## Product Change Notice (PCN)

**PCN Number: PCN-0451176R-01**

Product(s) Affected: PJ-046, PJ-046H

# Comparison plastic housing as below:

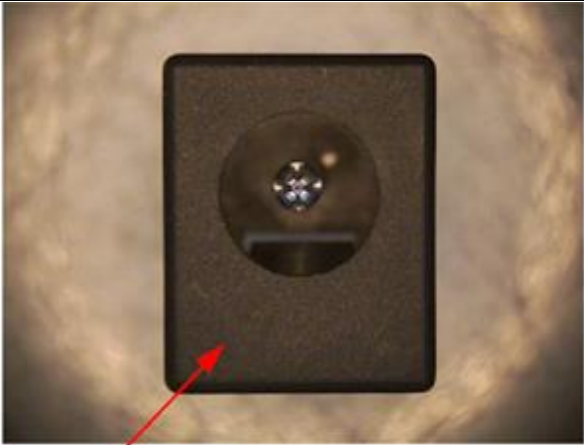
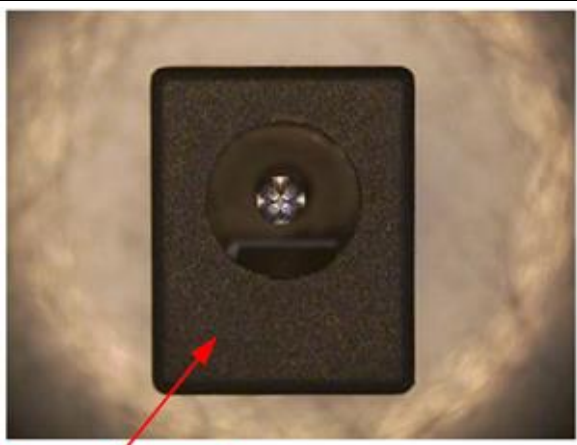
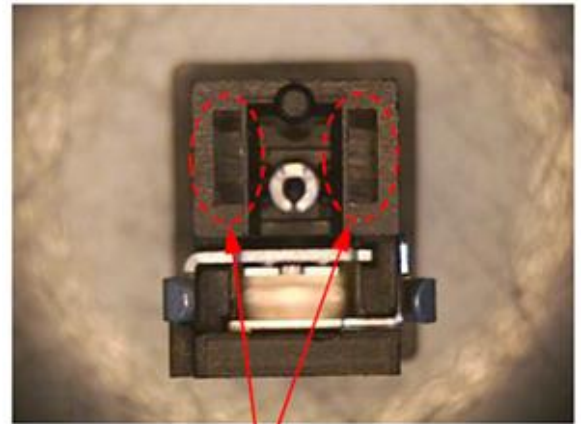
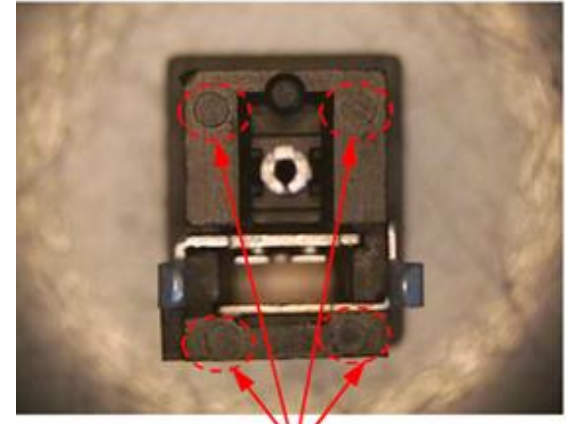
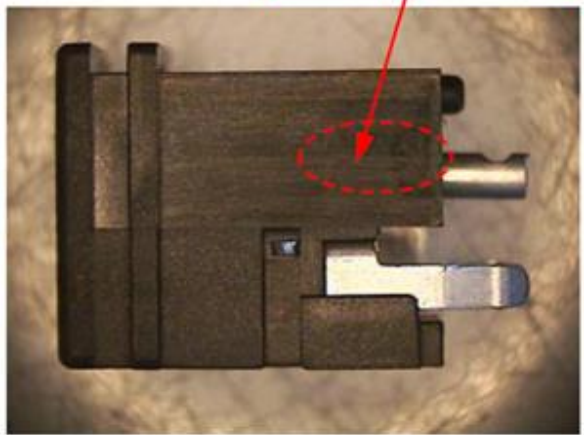
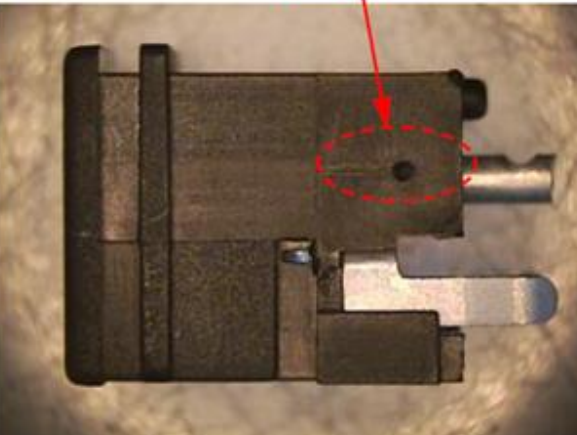
New version	Current version
Front	 <p>smooth surface</p>	 <p>rough surface</p>
Back	 <p>outlook different</p>	 <p>outlook different</p>
Left	 <p>smooth surface</p>	 <p>injection point</p>

Right

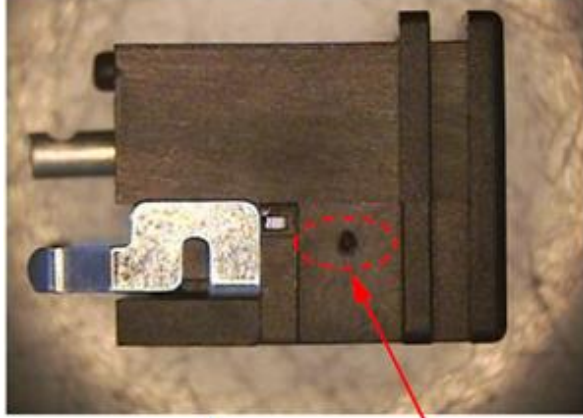
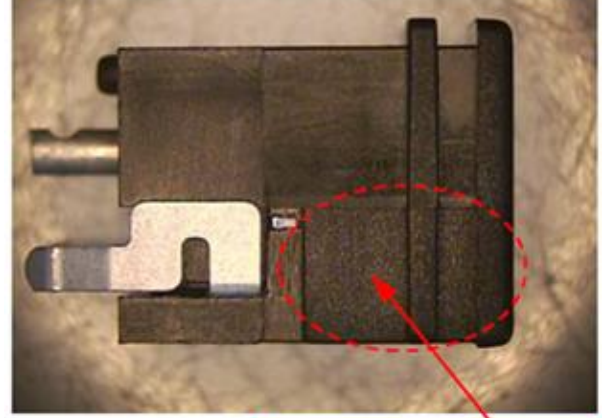
injection point

rough surface

Top

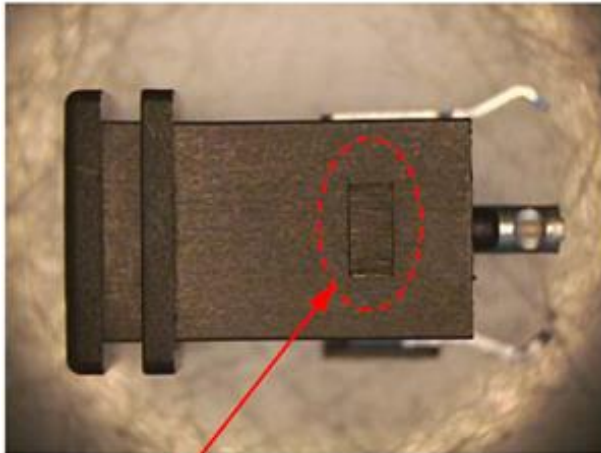
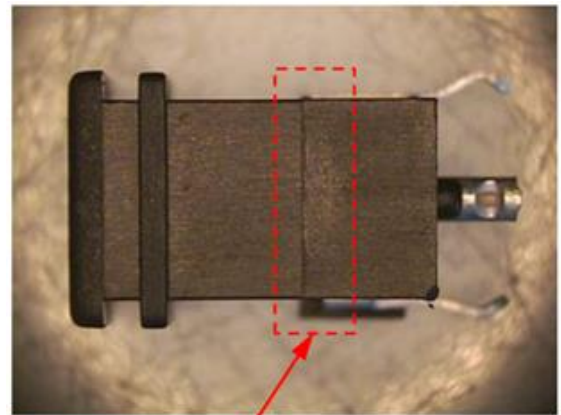
outlook different

outlook different

Bottom

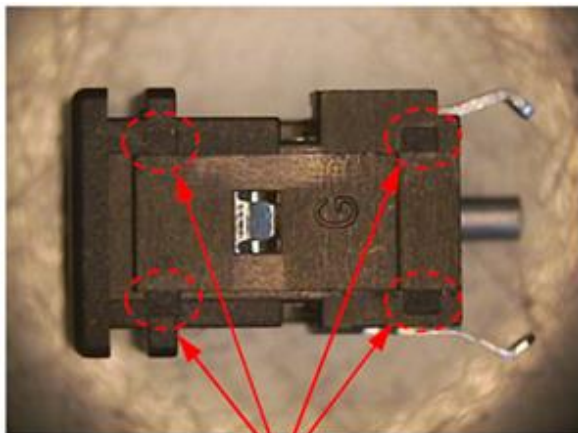
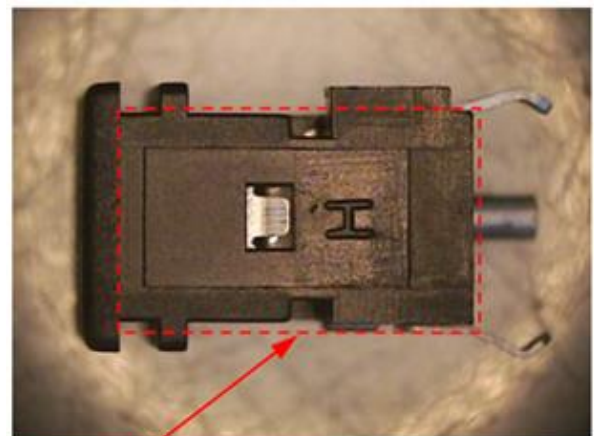
outlook different

outlook different
